26 West Hill Park
London, N6 6ND

Basement Impact Assessment
Audit

For
London Borough of Camden

Project Number: 12985-55
Revision: F1

Typical section through rear basement showing construction sequence

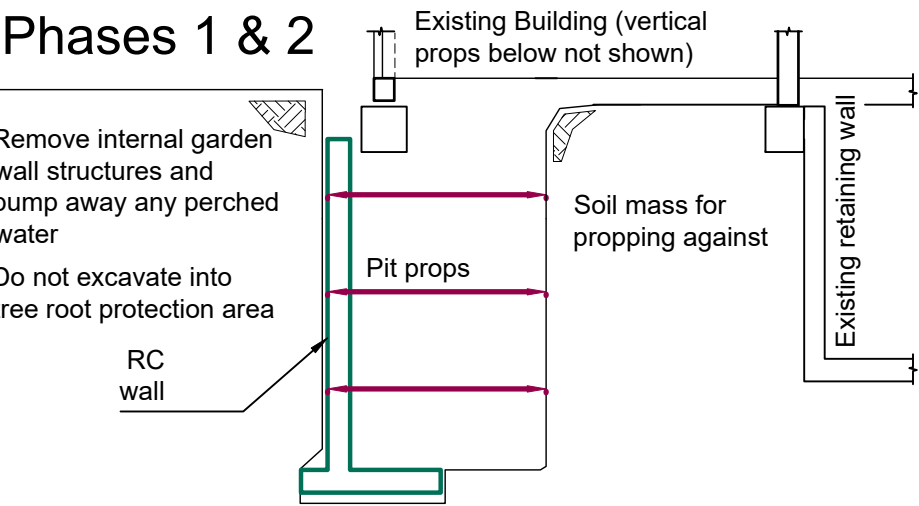
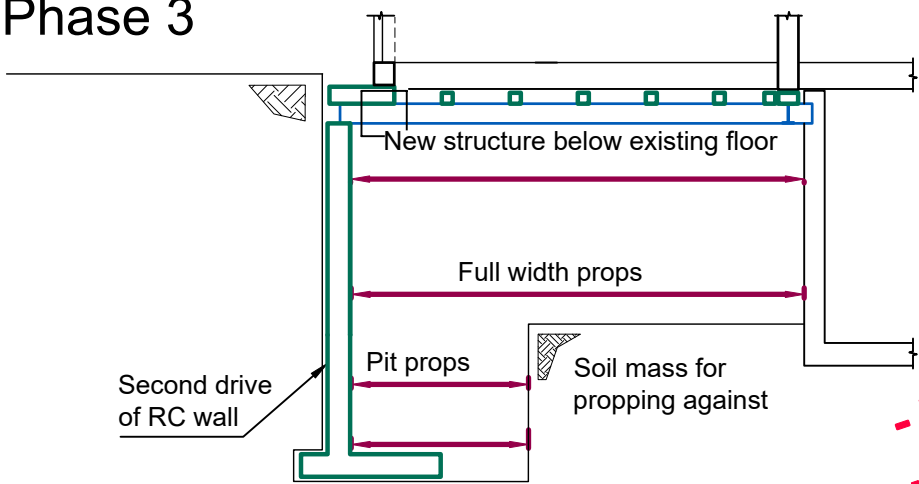
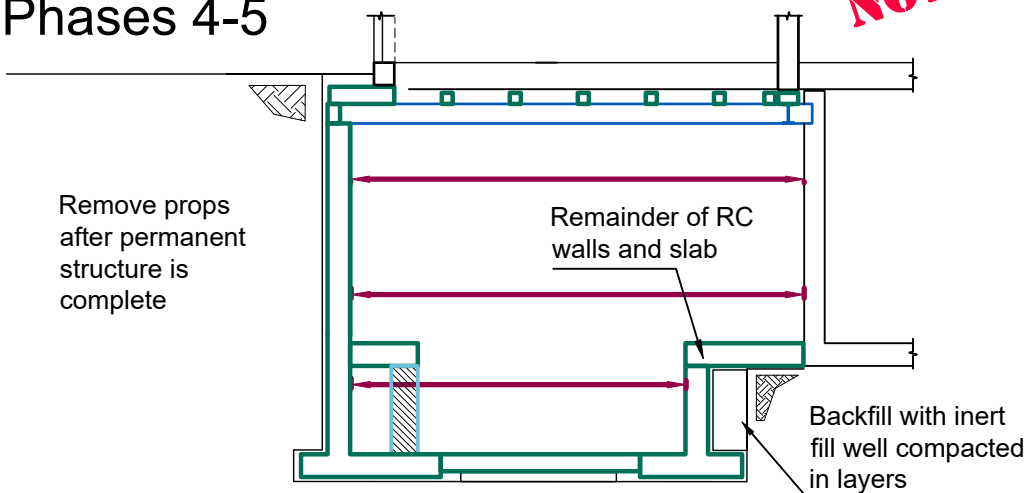
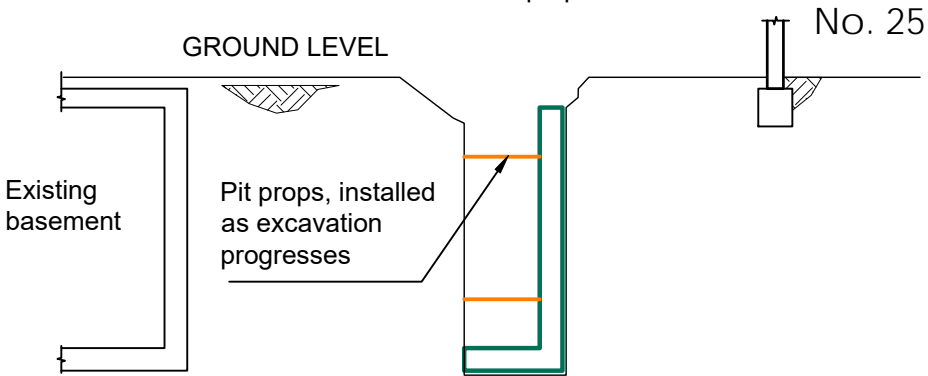
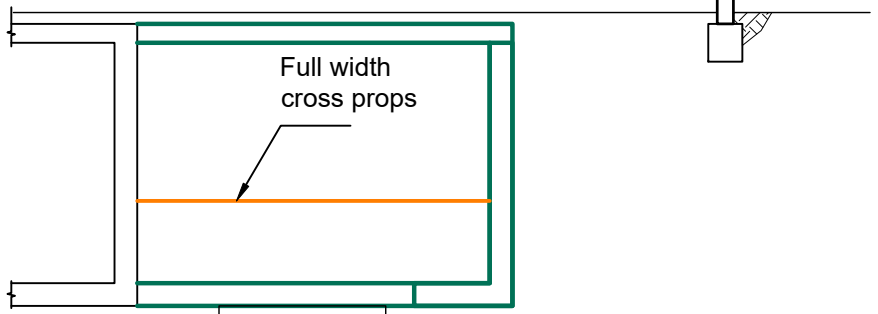
- 4.11. According to the revised Geotechnical BIA report, unsupported excavations in the Made Ground and the Claygate Member are likely to be unstable. For this reason, the proposed construction sequence included temporary propping with the floor slabs subsequently installed to act as permanent props in the long term. Sacrificial trench sheeting to stop potential collapse prior to concreting could also be adopted, however, it is understood that temporary works will be finalised post-planning and prior to construction.

The calculations assumes that the wall is propped high and progressively as the excavation proceeds at lower levels during construction and therefore a high stiffness can be assumed. Note the drawing the drawing 'Temporary Works Scheme Design' by Croft indicates such that this is the intended process. It is understood that there will be adequate propping in the temporary case to justify this assumption and in the permanent case the structure will provide adequate support to the retaining walls and act as a high-level prop.

3	28.11.2019	Sequence for rear basement simplified
2	01.02.2019	For New Planning Submission
1	04.06.2017	For Planning submission
-	21.04.2017	First issue for comment
Rev	Date	Amendments
